भारत सरकार
Government of India
विद्युत मंत्रालय
Ministry of Power
उत्तर क्षेत्रीय विद्युत समिति
Northern Regional Power Committee

Subject: Agenda for 37th Protection Sub-Committee Meeting.

Agenda for
37th Meeting of Protection Sub-committee of Northern Regional Power Committee

1. Complete outage of 400/220 kV G. Noida (UP) on 06 Nov 2018 at 22:40hrs (Discussed in 151st OCC meeting):

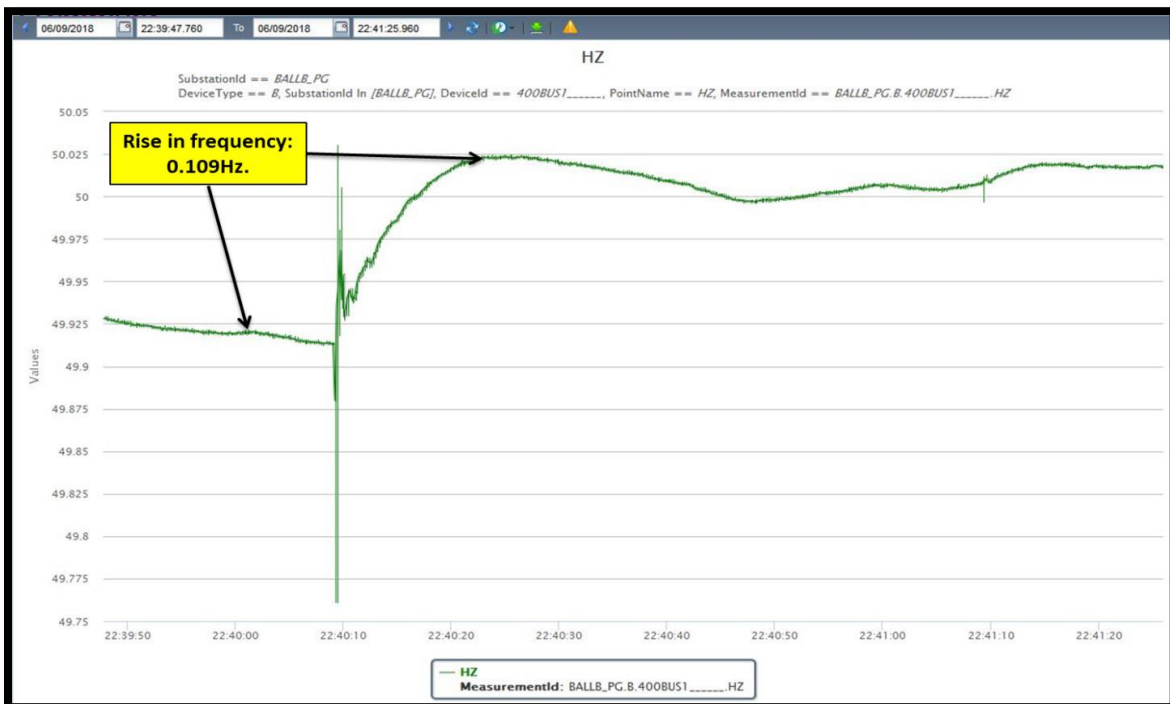
400/220 kV G. Noida (UP) station is an important load feeding station in Delhi NCR with 1630MVA (2*315MVA+2*500MVA) capacity. Connectivity Diagram is as below:

As per PMU data maximum dip in R-phase and fault clearance time was ~400ms. Delayed clearance of fault as per PMU data. PMU plot of phase voltages of Ballabhgarh (PG) is as below:

UPPTCL/ Haryana/ NTPC requested to submit the detailed report comprising the reply on above points.

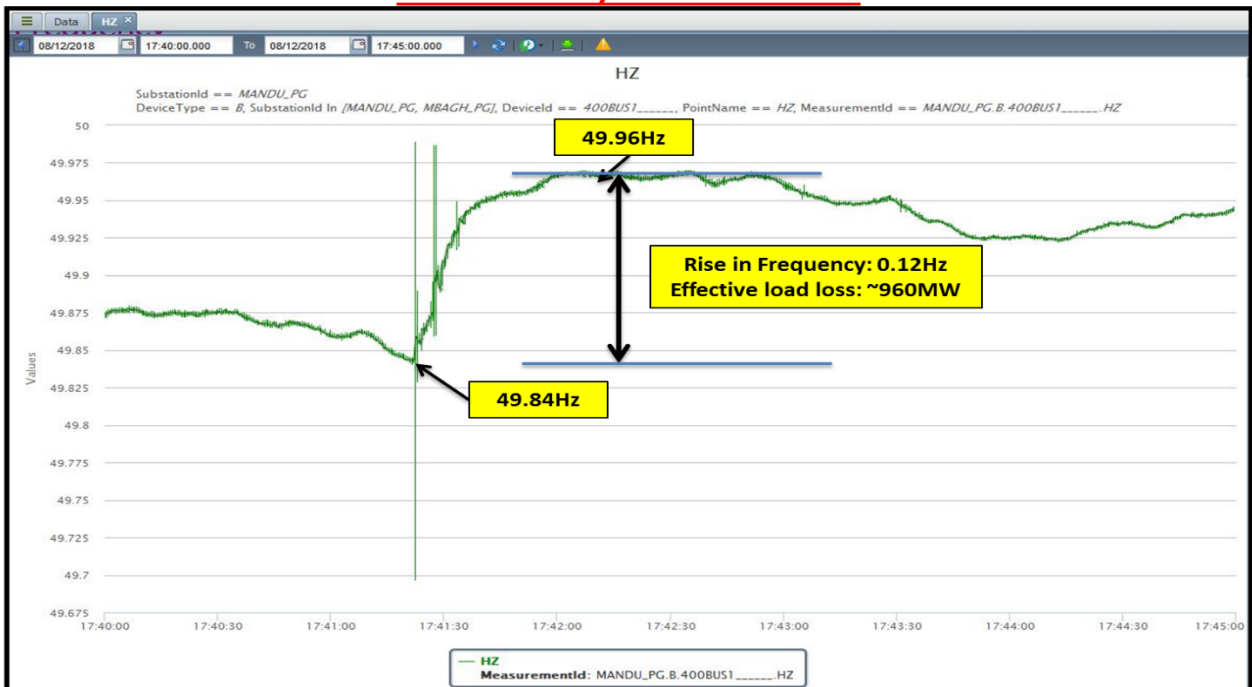
- As reported, B-N (LG fault) fault followed by R-Y phase to phase ground fault (LLG fault) occurred very near to gantry of the Dadri end of 400 kV Dadri-G. Noida line and Dadri-Maharani Bagh line on 08th December 2018, at 17:41:22 and 17:41:27 Hrs respectively.

- In antecedent condition 400 kV Maharani Bagh-Ballabgarh ckt and G. Noida-Nwada ckt was already under shutdown and 400 kV Dadri-G. Noida ckt was in Non-auto mode due to ongoing work on OPGW wire.

- Shutdown of 400 kV Maharani Bagh-Ballabgarh ckt and 400 kV G.Noida-Nwada was extended for more than 22 days from its approved time. It is serious cause of concern and NRLDC already wrote a letter to POWERGRID.
- Load relief for load group C&D in case of SPS operation of HVDC Rihand-Dadri Pole-II was very low compare to planned load shedding of 520MW.
- Unwanted operation of RoCoF protection in Punjab is cause of concern as it is a clear failure of last defence mechanism.

DR details of 400 kV Gorakhpur PG(end)-Gorakhpur UP ckt-2

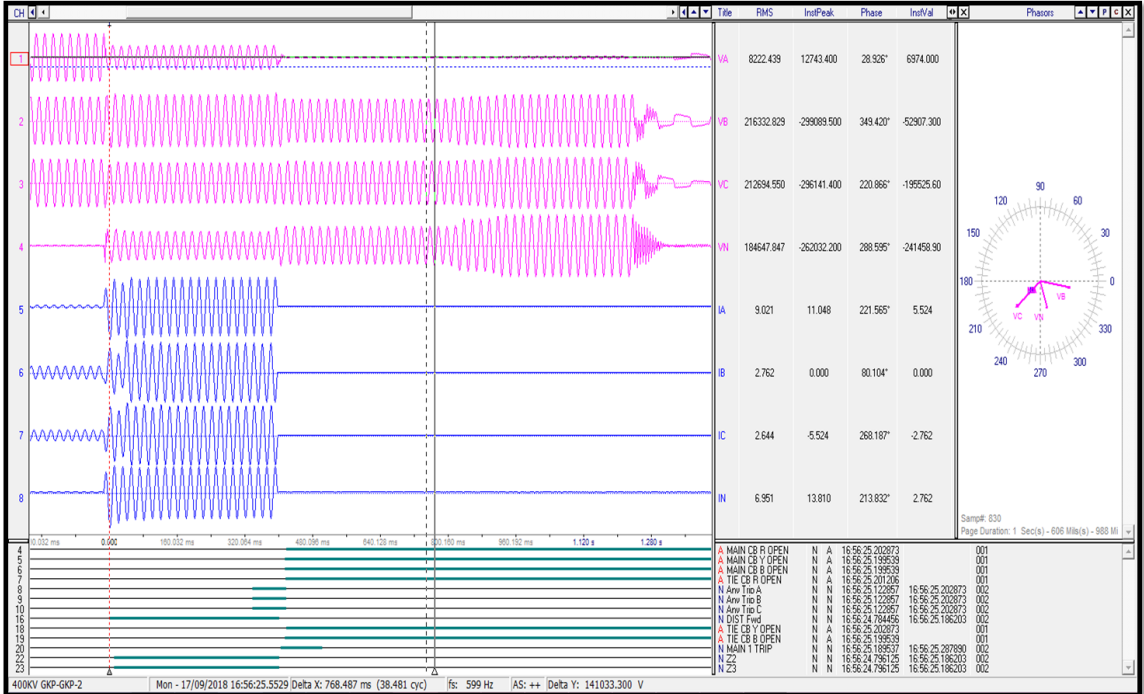
It seems line tripped from PG end in Z-2. Gorakhpur (UP) end connected for another 800ms as voltage persisted for that period.

DR of 220kV KTPS (end)-Sakatpura ckt-2

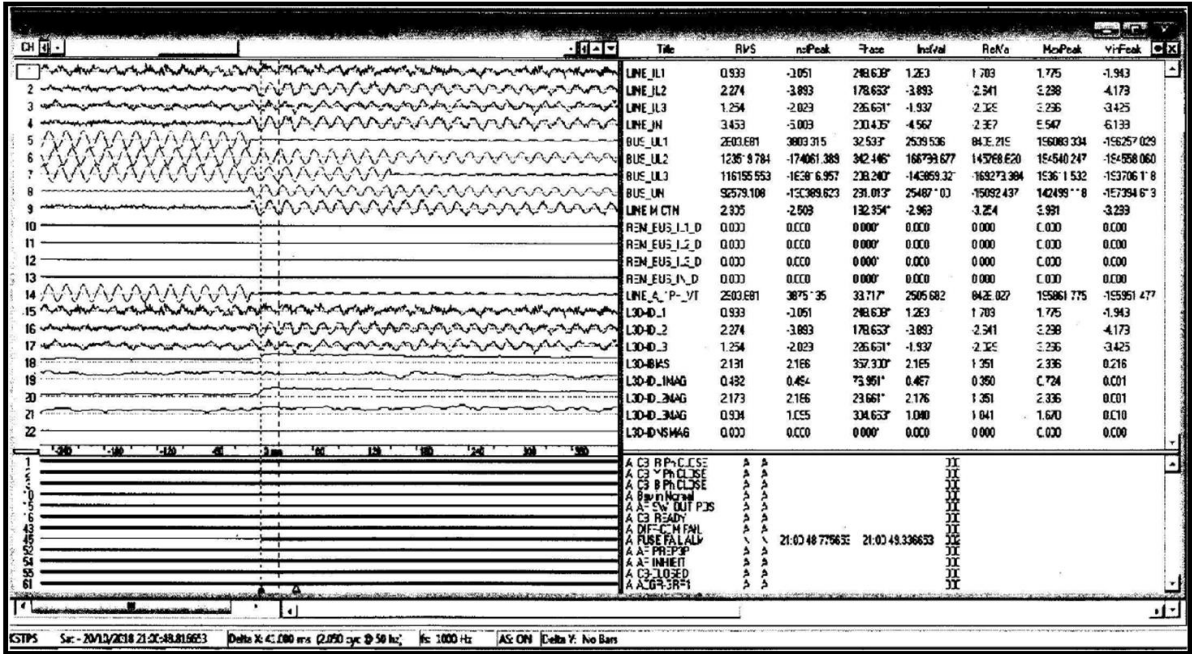
Differential protection didn't operate. Line tripped from Sakatpura end on O/C E/F protection

DR of 220kV KTPS (end)-Sakatpura ckt-4

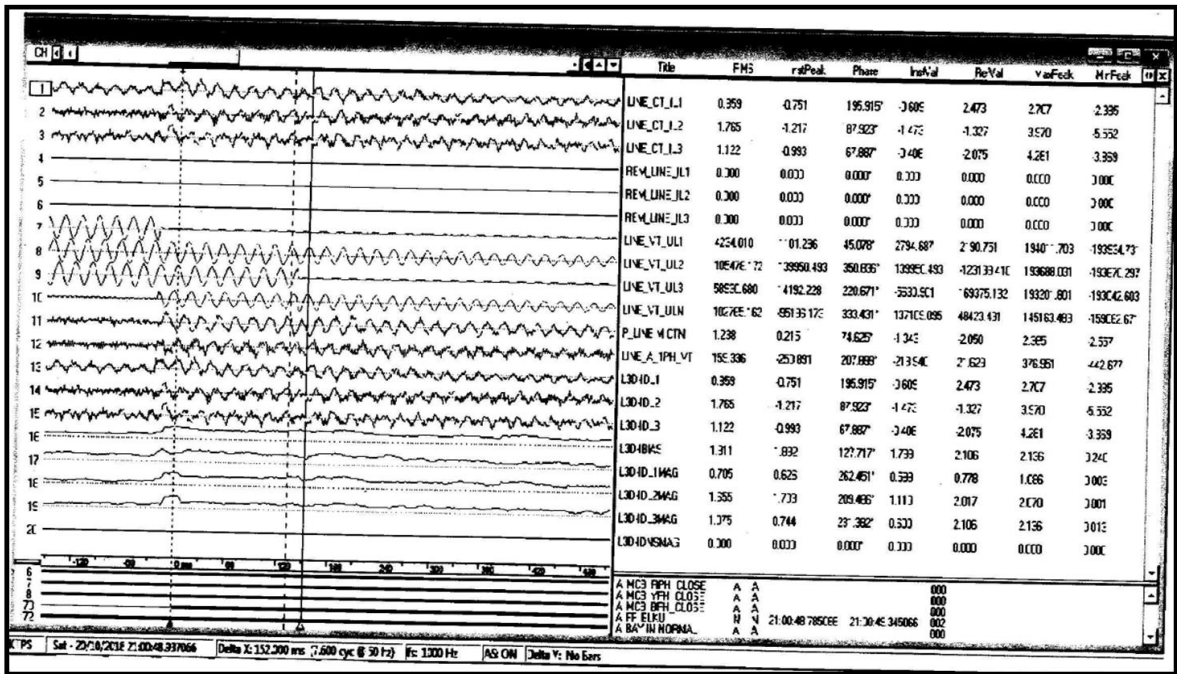
Differential protection didn't operate. Line tripped from Sakatpura end on O/C E/F protection

DR of 220kV Sakatpura (end)-KTPS 4

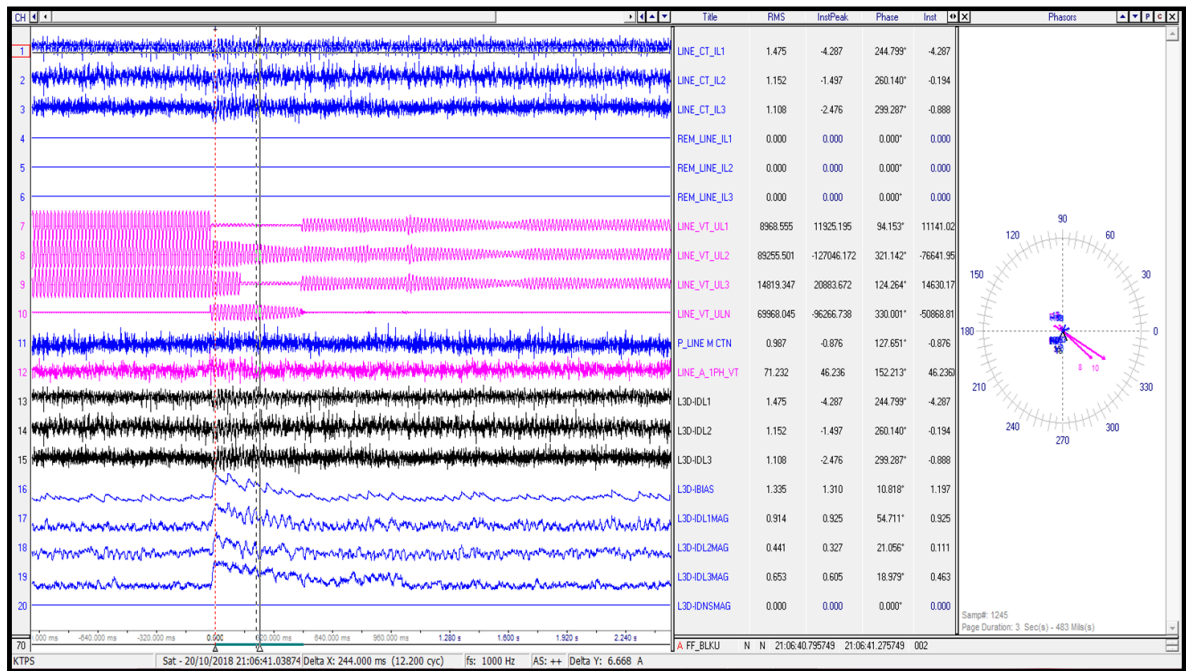
Time Synch error, as DR triggering time is different from actual fault time

DR of 220 kV Bhiwadi (PG) (end)-Kushkhera

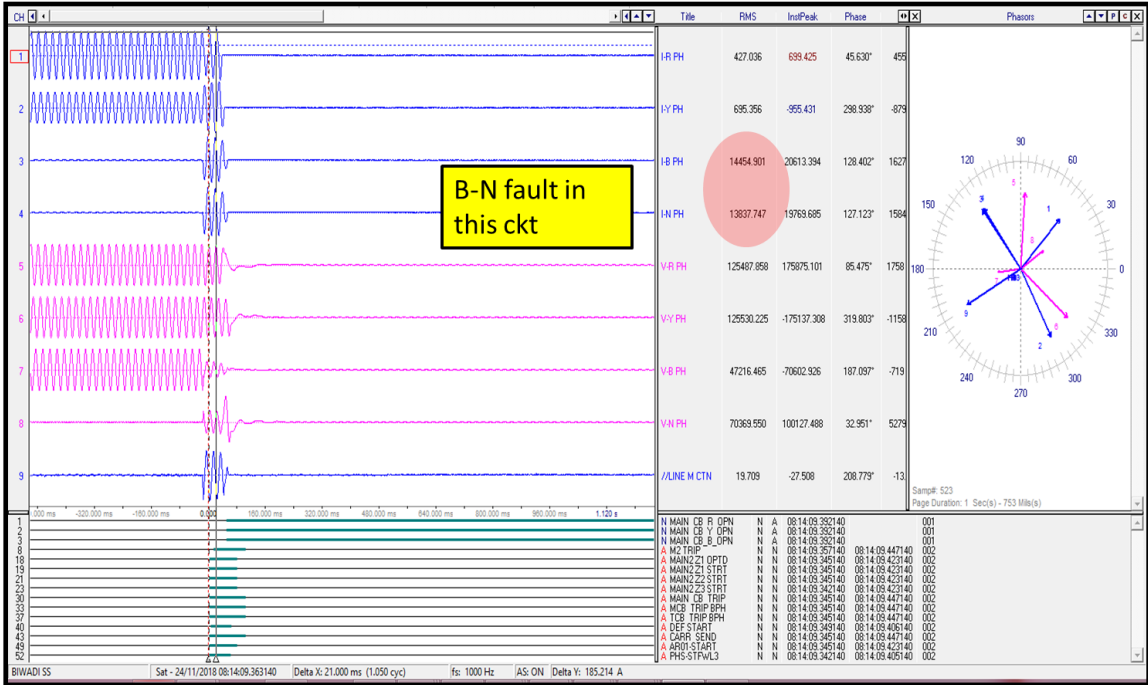
All three phase of the line tripped from both end without any auto reclosure operation on B-N (Blue phase) fault. A/R needs to be checked and put in service at both end.

DR of 220 kV Bhiwadi (PG) (end)-Bhiwadi (Raj) ckt-2

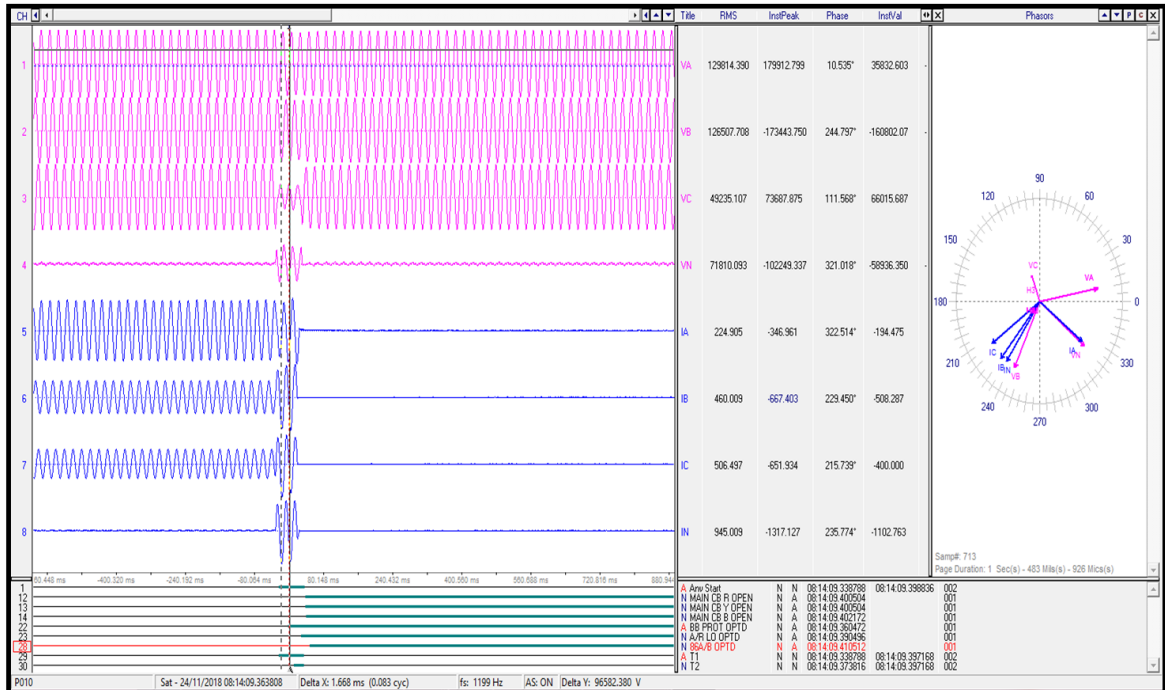
Tripped on master trip relay operation

DR of 220 kV Bhiwadi (PG) (end)-Mau

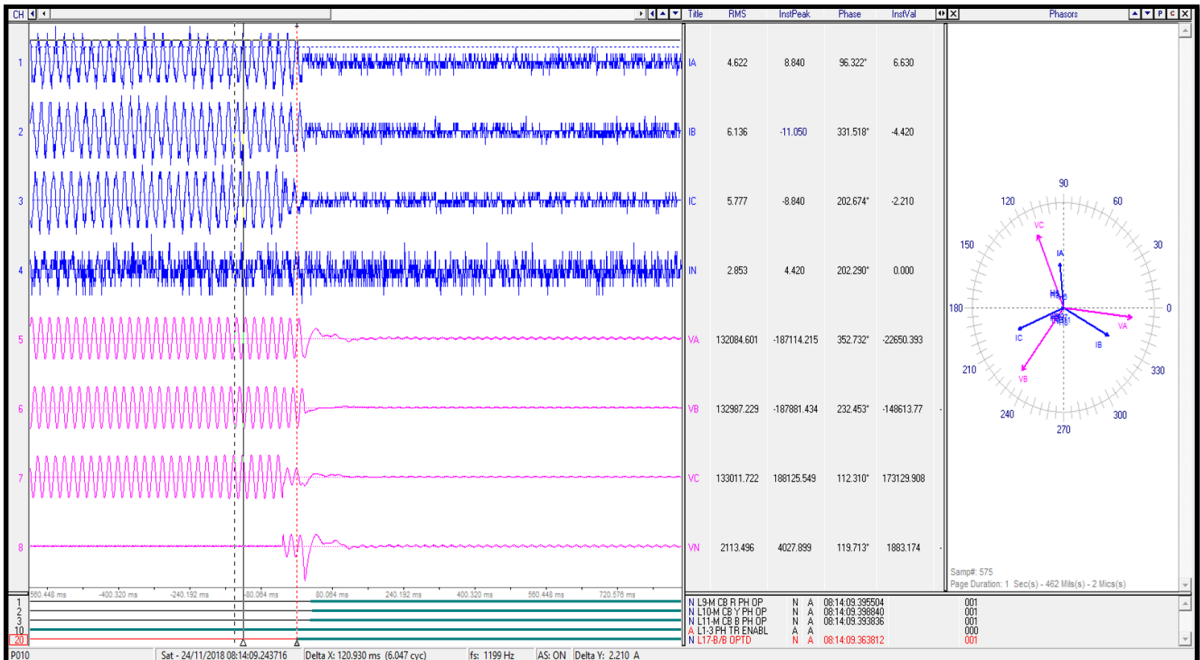
It seems line charged from Bhiwadi (PG) end only. Bus Bar protection operated at Bhiwadi (PG)

DR of 400 kV Kirori (end)-Kheddar ckt-2

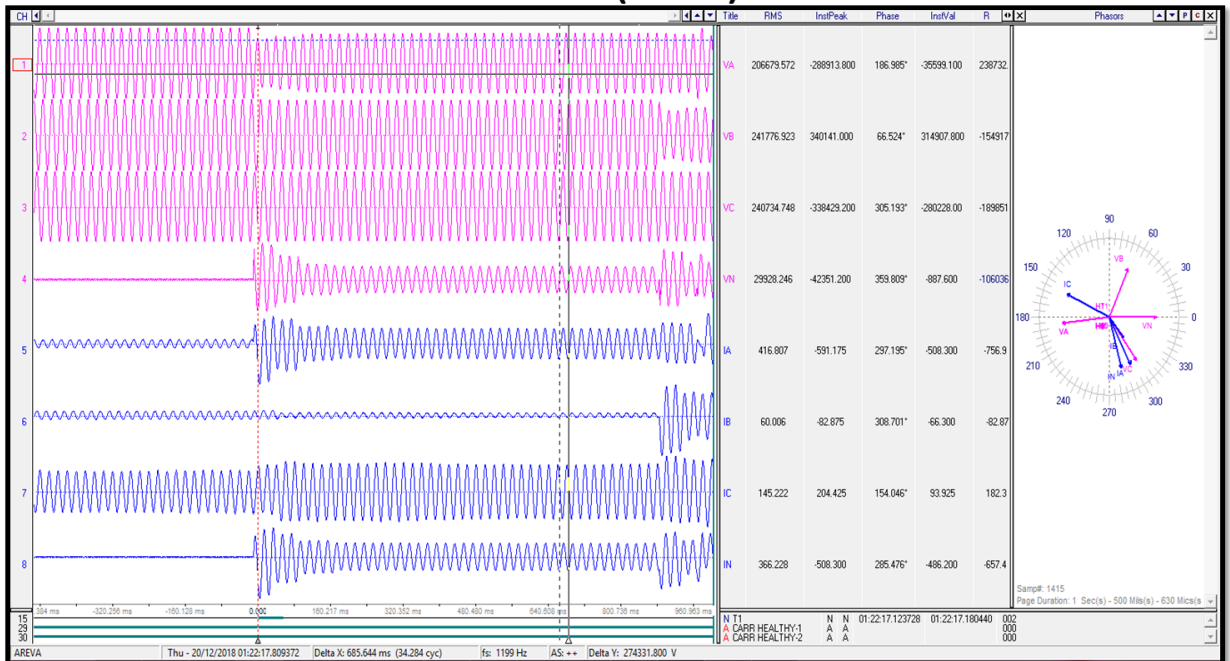
R-N fault line tripped after 1000ms probably on Z-3/reverse zone protection. (Why only single phase tripping occurred?)
 After 1200ms of opening of R-phase CB, Y&B-phase also tripped probably on PD (Pole discrepancy)

DR of 400 kV Kirori (end)-Khedar ckt-2

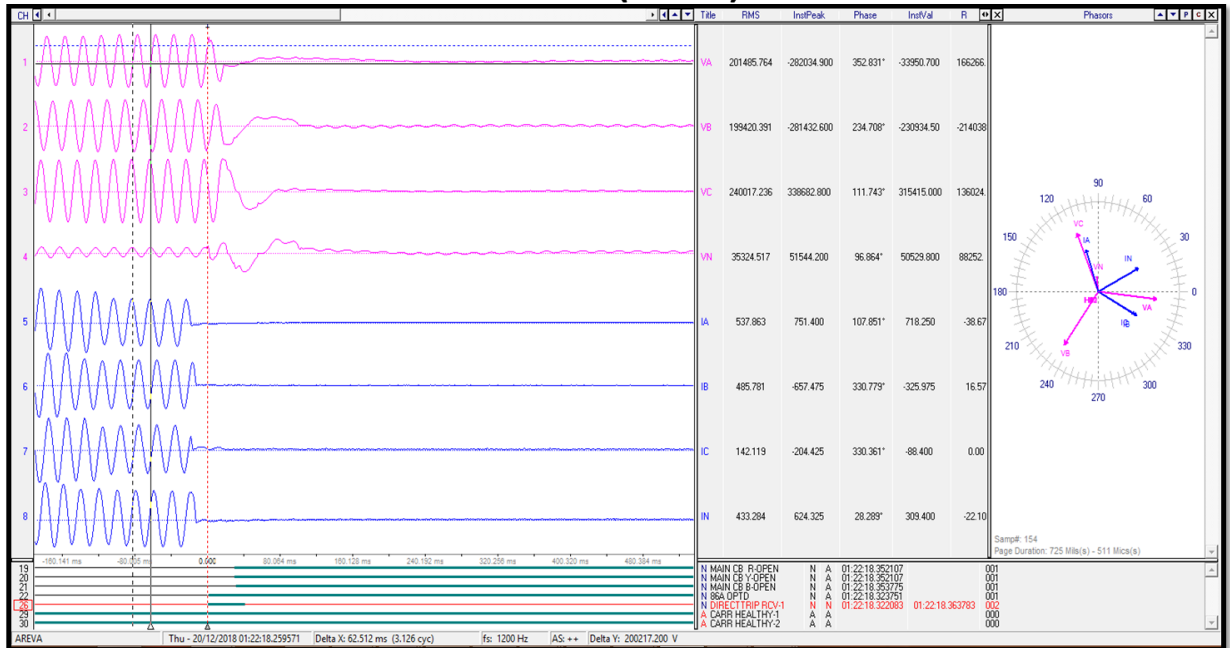
It seems line didn't trip from Kirori end however as per SCADA SoE line tripped within 320ms from Kirori end.
